SERVICE BULLETIN

DATE: 20 JULY 2010

INSPECTION OF SHORT EDGE MARGIN CONDITION ON 369D23500 TAILBOOM ASSEMBLY

Figure 2. STA 209.78 Frame Ring to Rivet Measurement

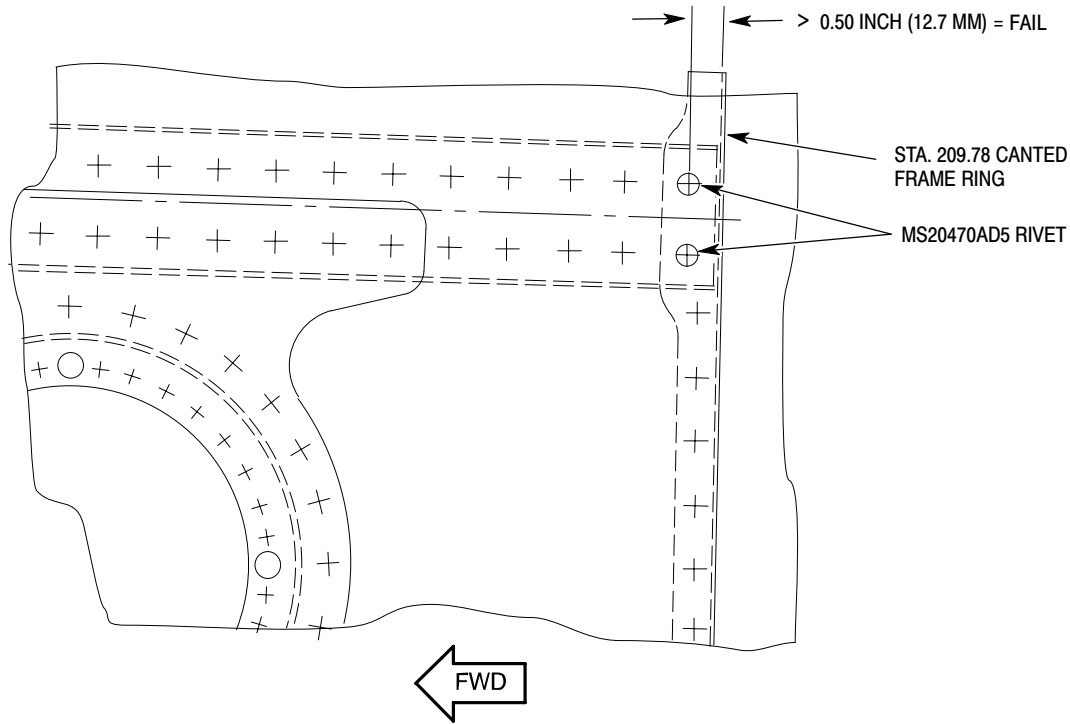
- Measure the distance from the forward face of the STA 209.78 frame ring to the center of the two aft rivet locations on each longeron.

If either of the two aft rivets for a longeron is more than 0.50 inches (12.7mm) from the forward face of the frame ring, there is an unsatisfactory edge margin condition.

- Record the pass or fail result for each rivet in the last column of the table above.
- Mark each rivet that fails the edge margin inspection.

Figure 3. Repair Doubler

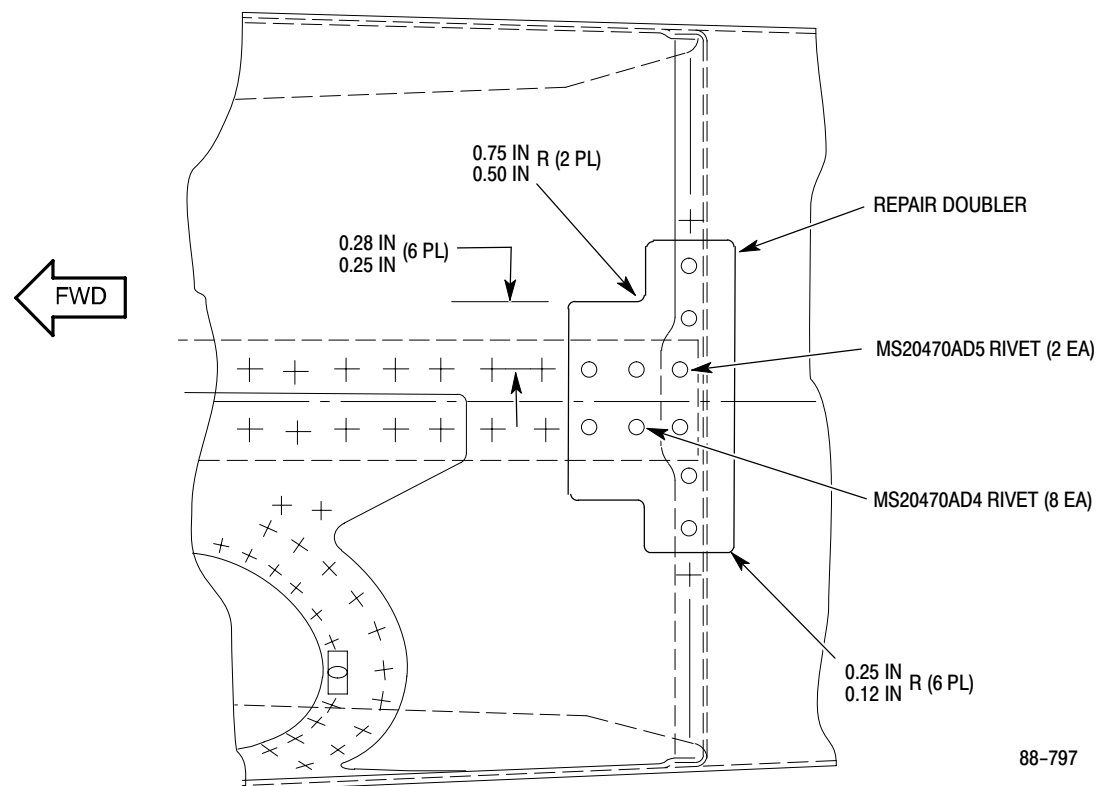
- (1). Carefully remove the ten rivets shown in Figure 3.
- (2). Fabricate a "T-shaped" repair doubler using 0.063 inch thick 2024-T3 Alclad, per QQ-A-250/5.

- (3). Size the repair doubler such that there is a 0.250 inch (6.35mm) to 0.280 inch (7.11mm) edge margin around the perimeter of the repair doubler.
- (4). Shape the repair doubler so it has a radius of approximately 5.722 inches (145.34mm) to agree with the shape of the tailboom. See Figure 4.

- (5). Put the repair doubler on the tailboom assembly and drill pilot holes in the repair doubler at existing rivet locations.
- (6). Remove the repair doubler and drill full size holes at each hole location to match final rivet diameter.

Figure 4. Repair Doubler Installation

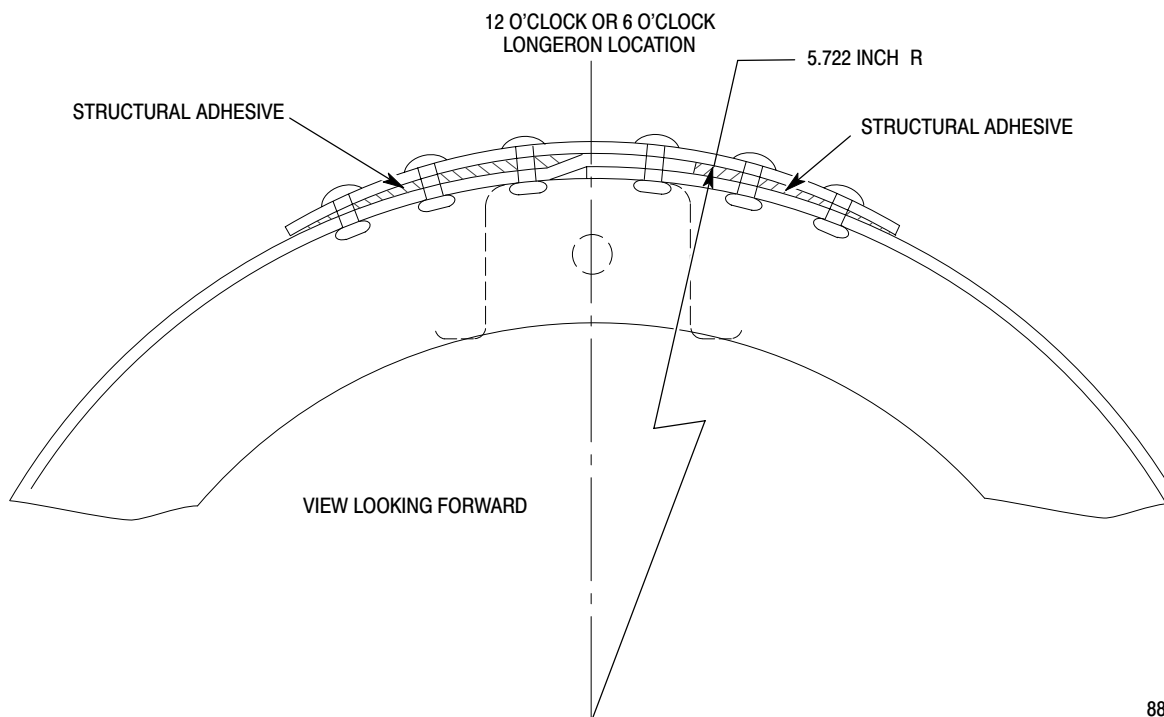
- (10). Apply primer (CM318) to all non faying surfaces of the repair doubler.
- (11). Apply structural adhesive (EA9394) to the faying surfaces of the repair doubler.
- (12). At the 6 O'Clock and 12 O'Clock longeron location, apply structural adhesive (EA9394) to the tailboom surface as shown in Figure 4.
- (13). Install the repair doubler with eight (8) MS420470AD4 rivets and two (2) MS20470AD5 rivets. Install all rivets with wet primer (CM318) and allow adhesive and primer to cure.
- (14). Fillet seal the edges of the repair doubler with structural adhesive (EA9394).
- (15). If necessary, touch up the finish of all parts per CSP-HMI-2, Chapter 20.
